# ADDENDUM NO. 2

**JACKSON ELEMENTARY SCHOOL RENOVATIONS**  
**Valparaiso, IN 46304**

**Addendum Two (AD.02)** to the drawings and specifications prepared by Gibraltar Design for **Jackson Elementary School Renovations** for Duneland School Corporation, Chesterton, Indiana.

**A-301**

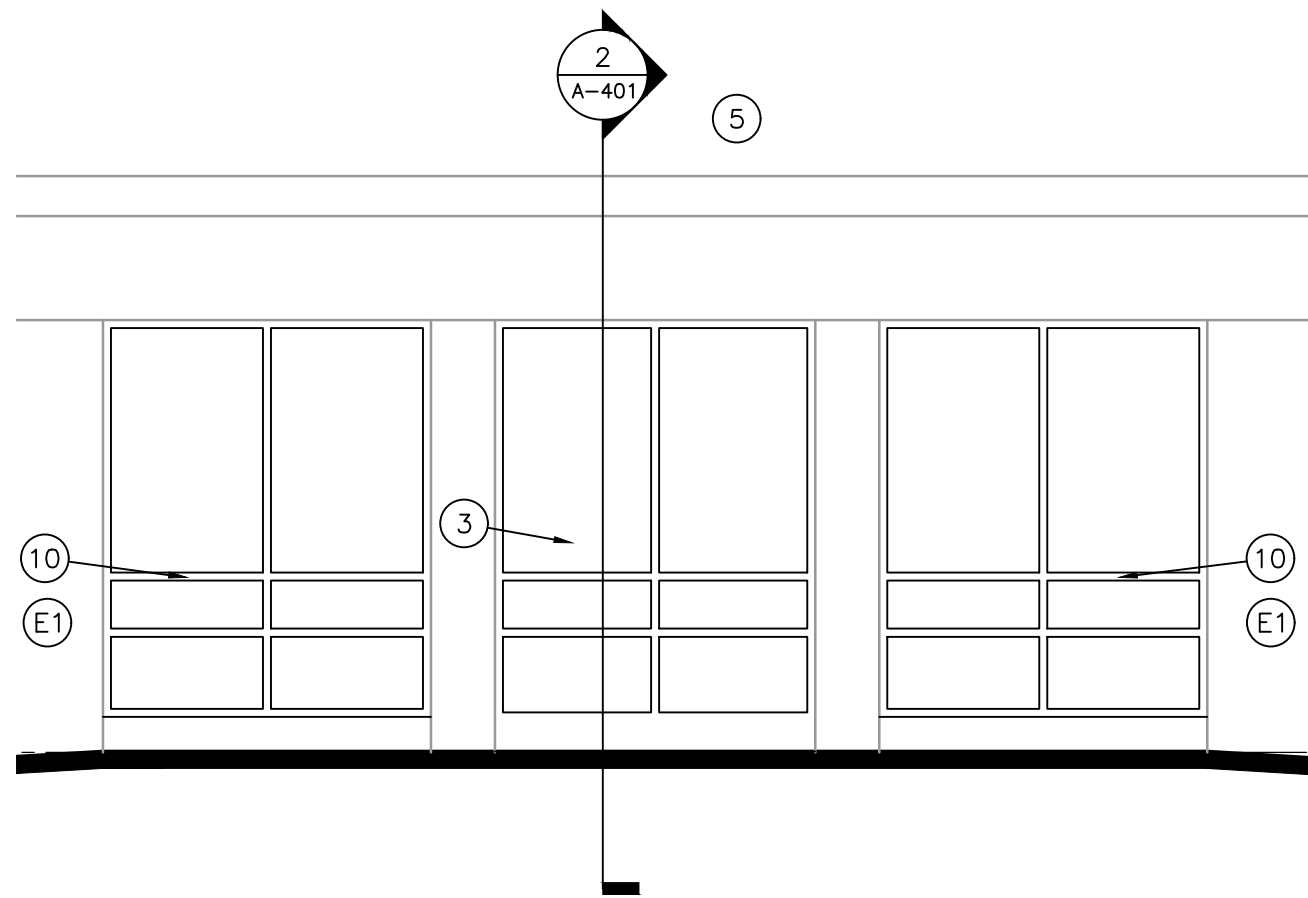
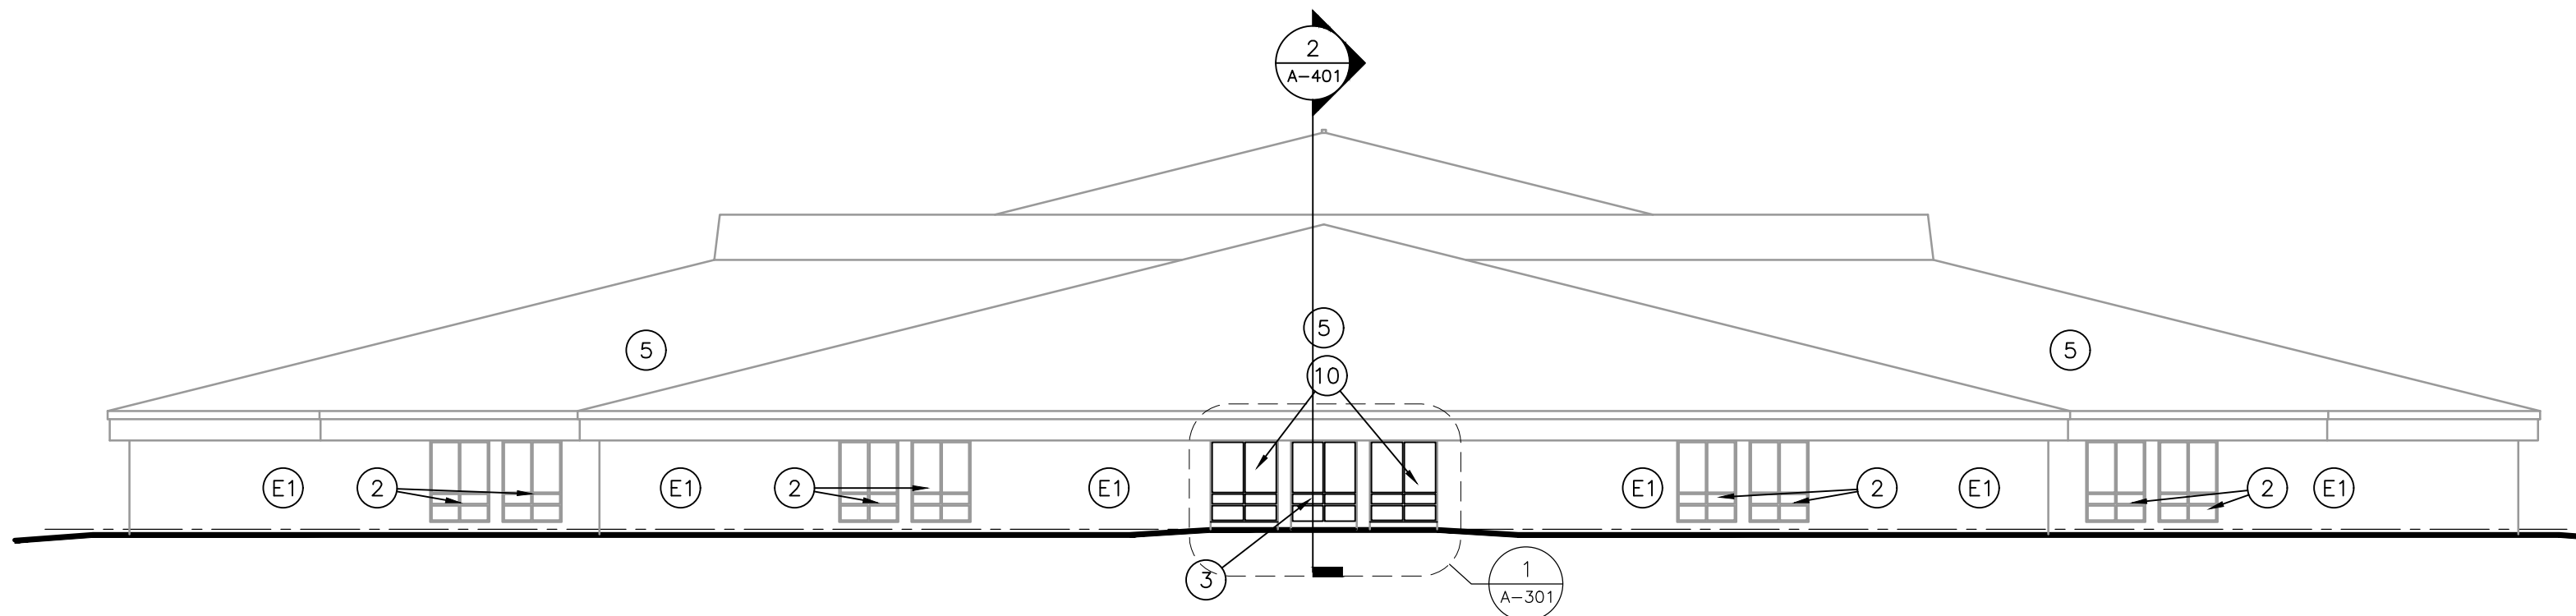
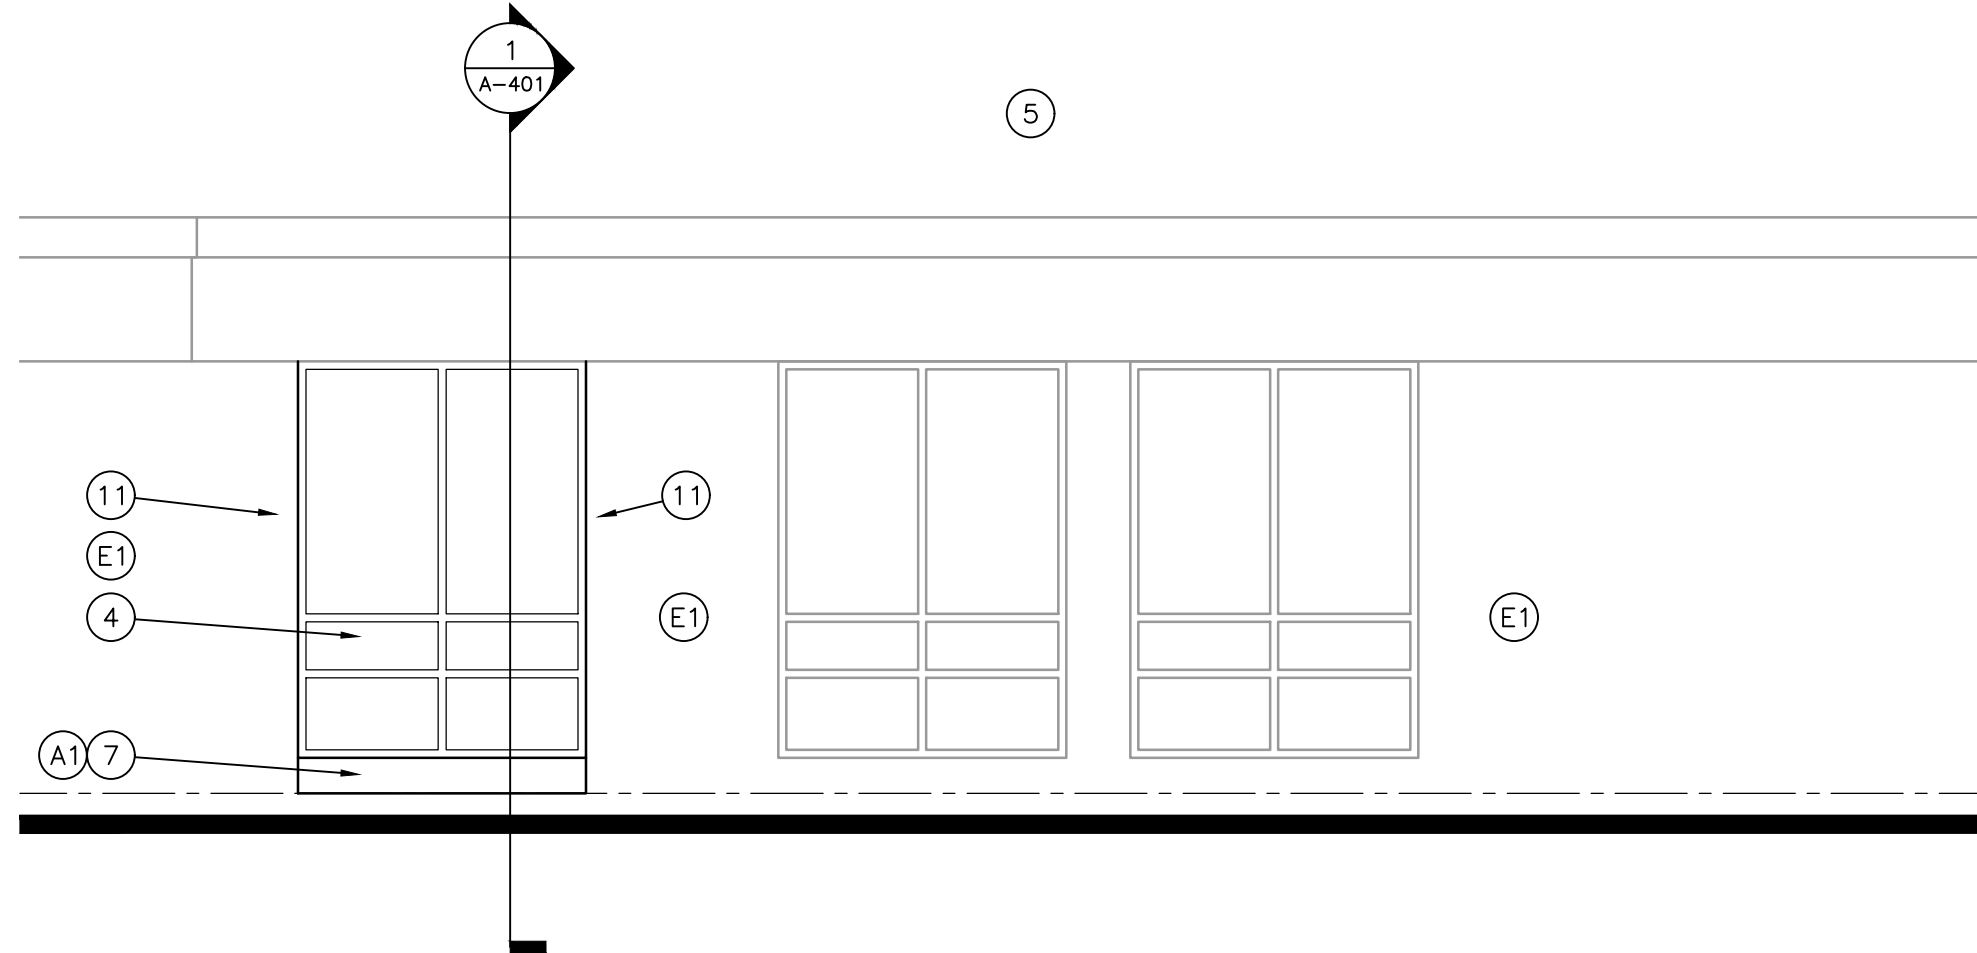
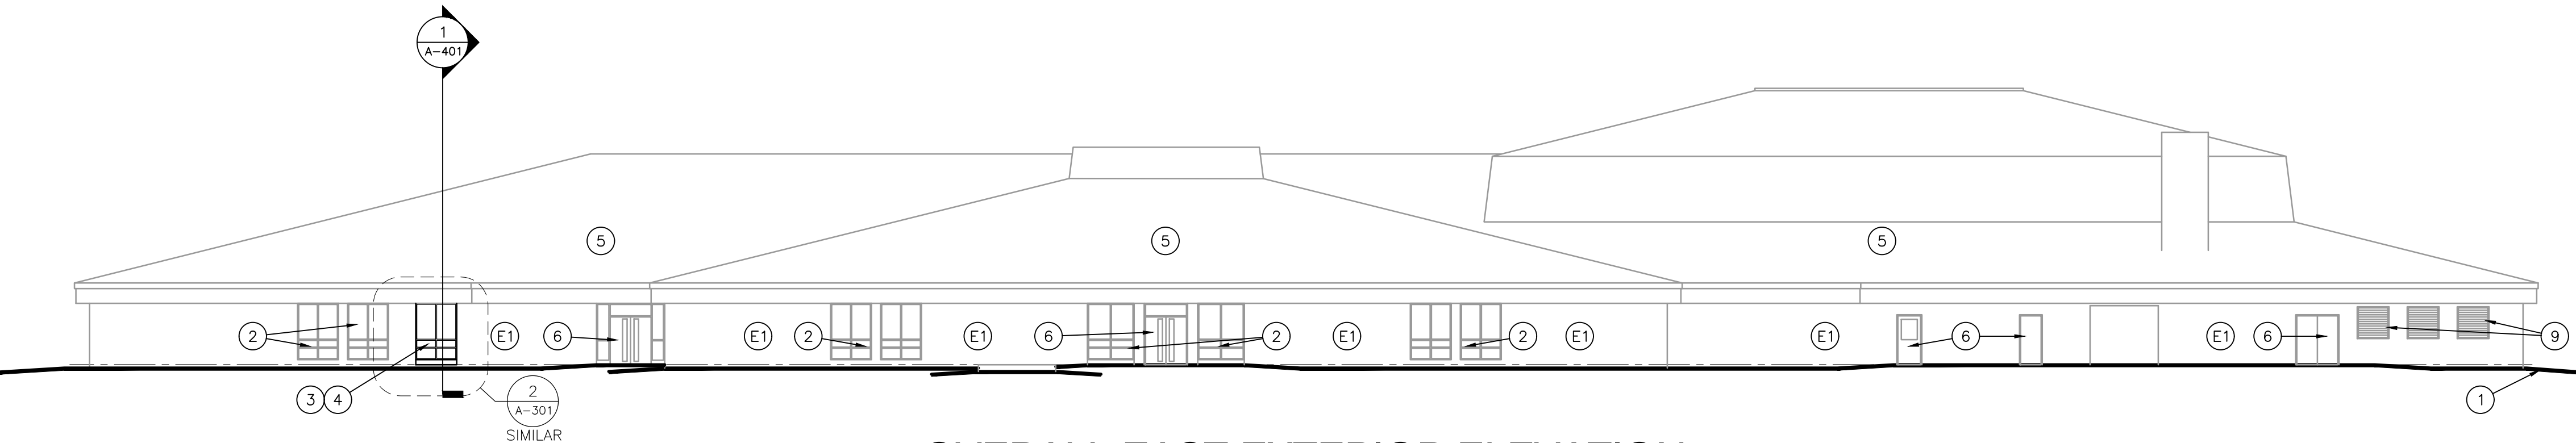
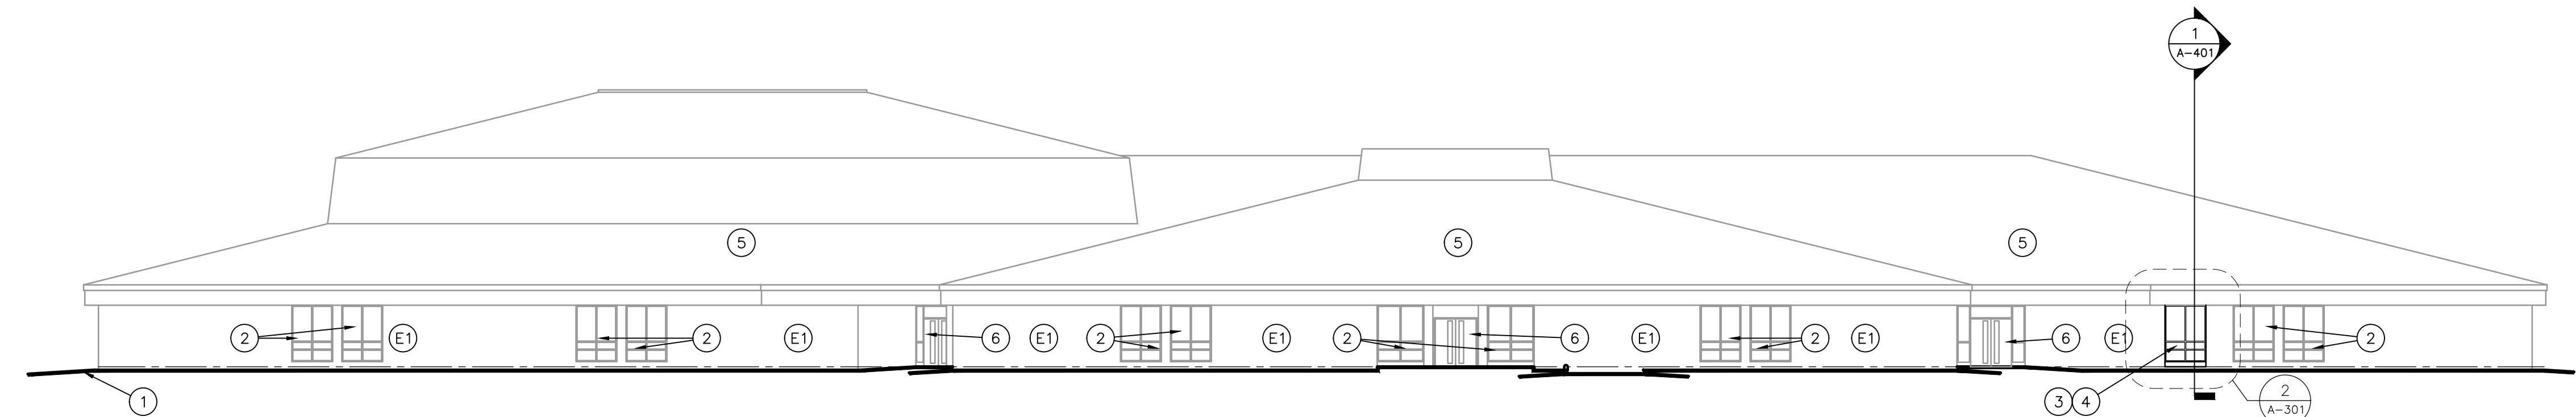
### 1. Sheet A-301

- A. Refer to revised full size drawing, included in this Addendum, for the following revisions:
  - 1. Added detail numbers.
  - 2. Revised Elevation Key Notes item 7.
  - 3. Added A1 Brick and Stone Type Notes designation.

© GIBALTAR DESIGN SHEET  
**B P-112**

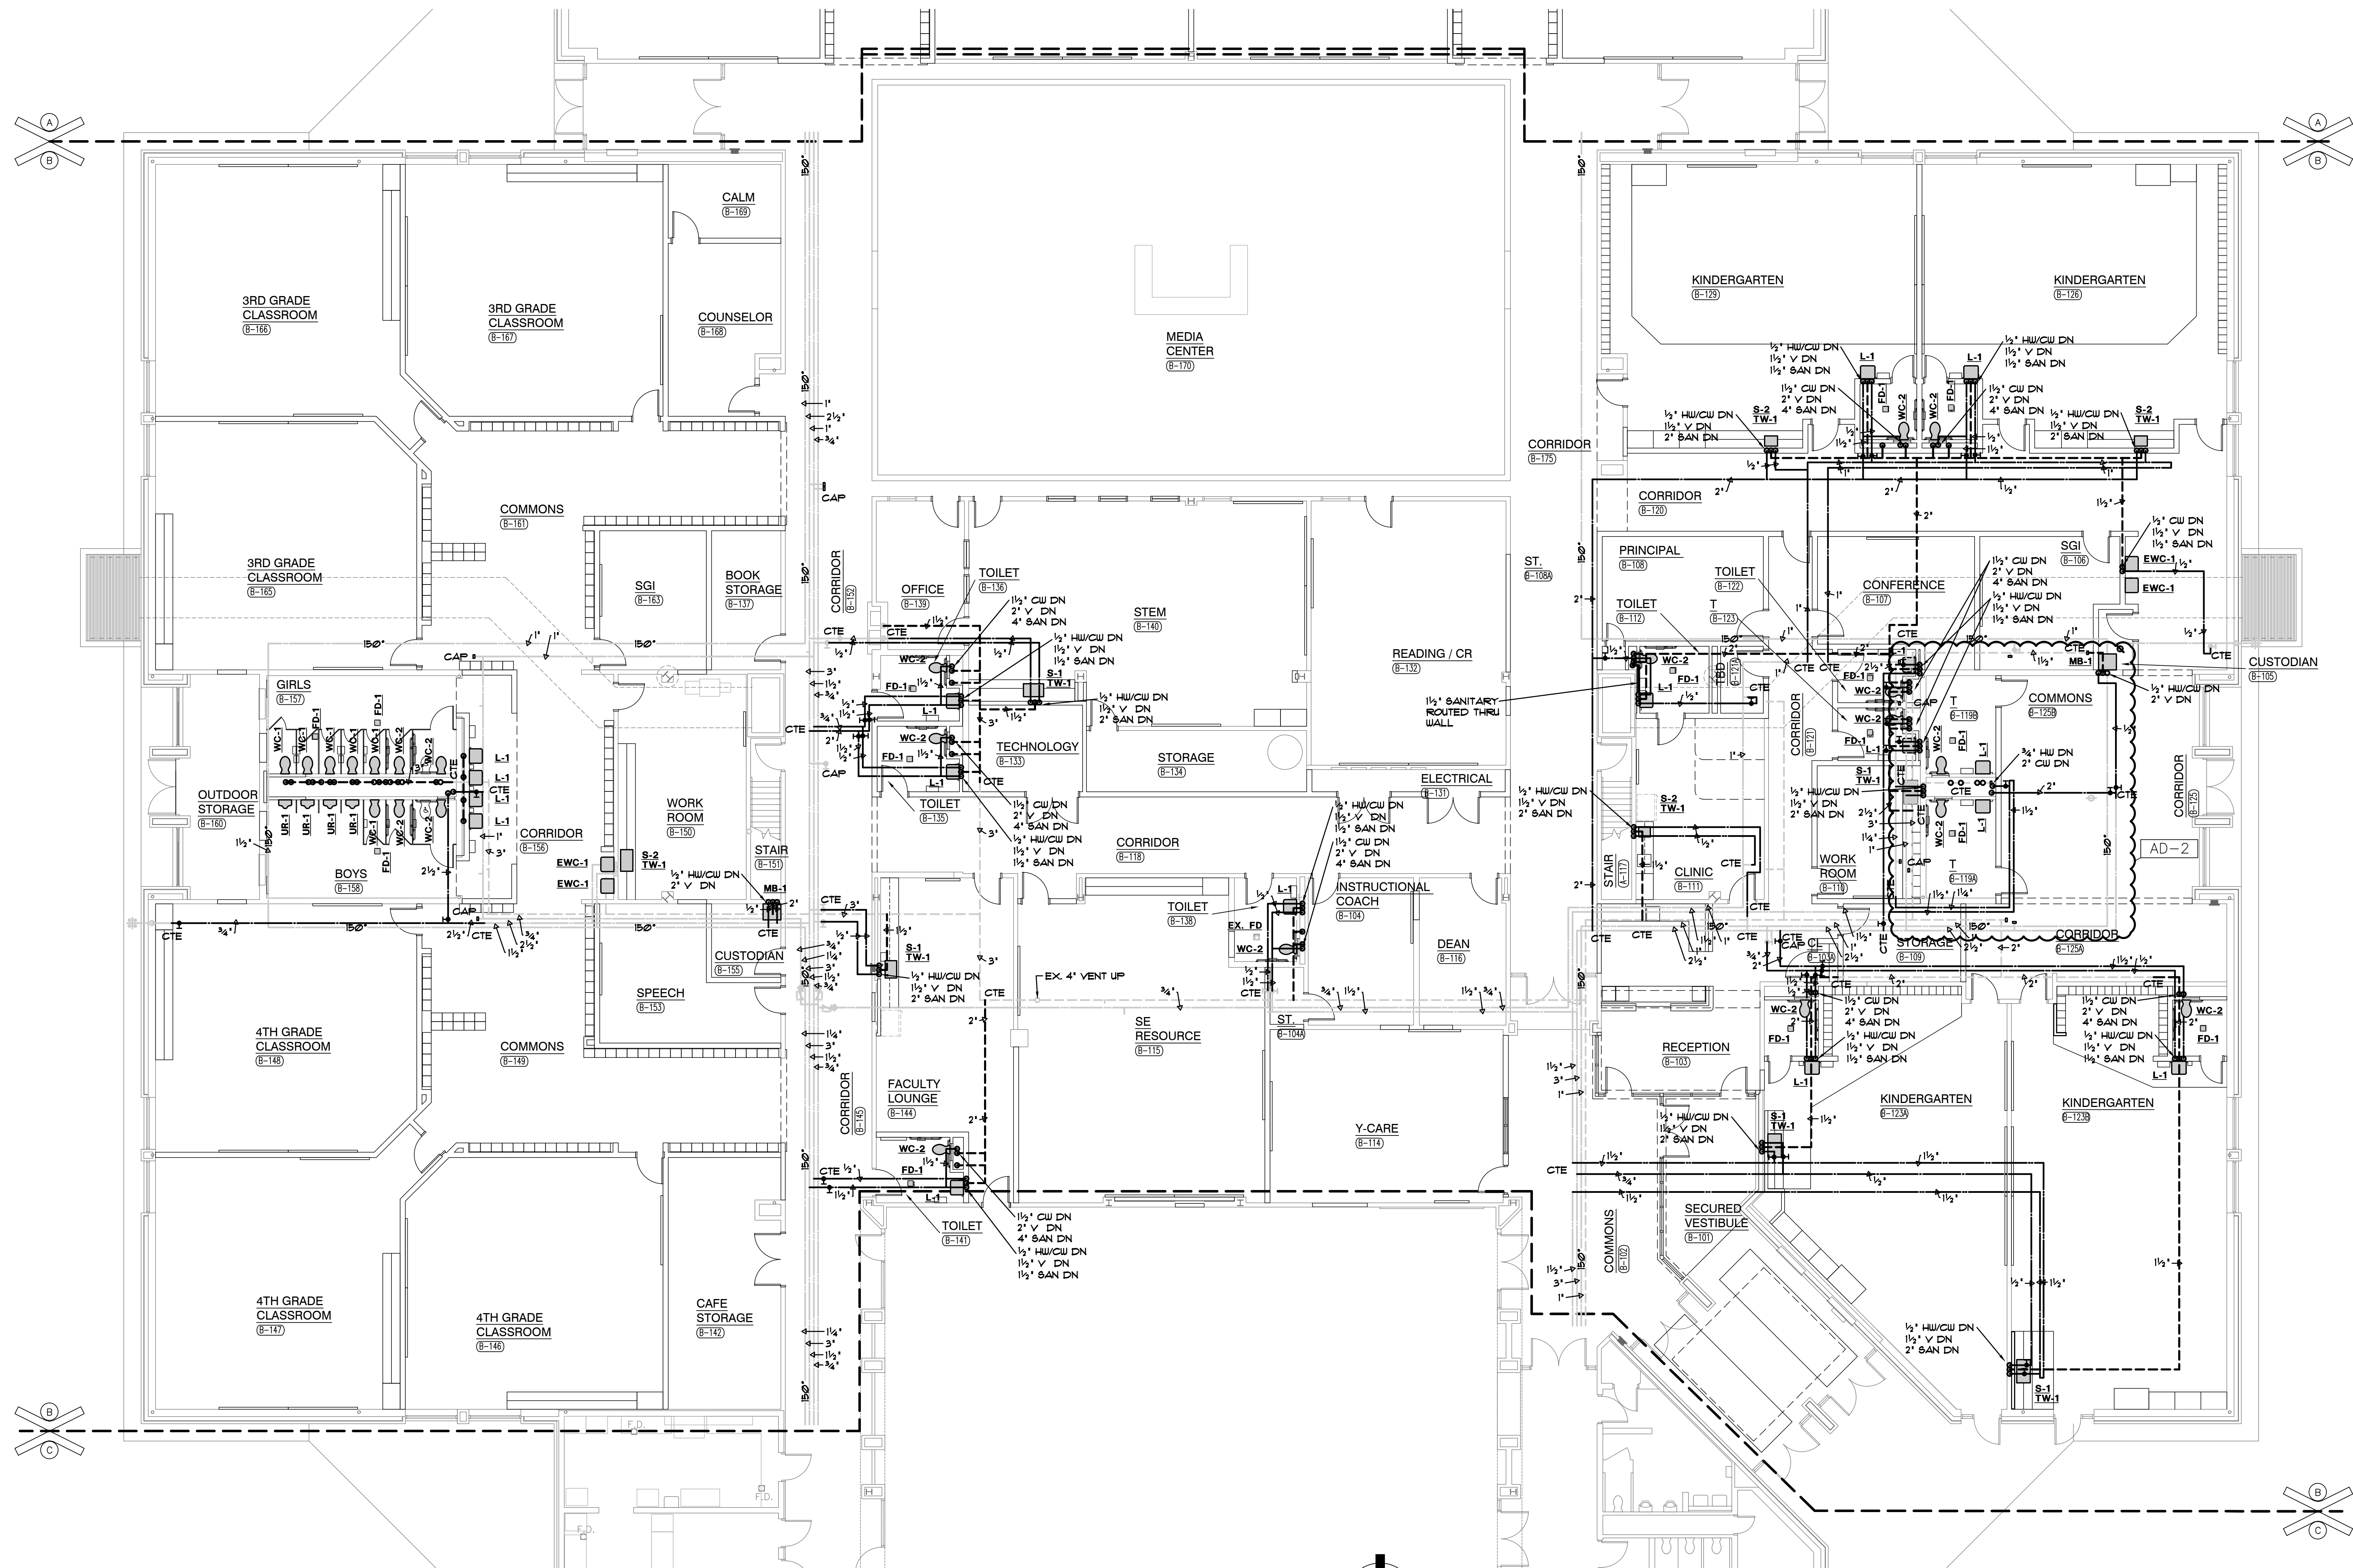
### 5. Sheet P-112

- A. Refer to revised full size drawing, included in this Addendum, for the following revisions:
  - 1. Revised domestic CW, HW, HWR and vent piping for new Toilets B-119B and B-119A.
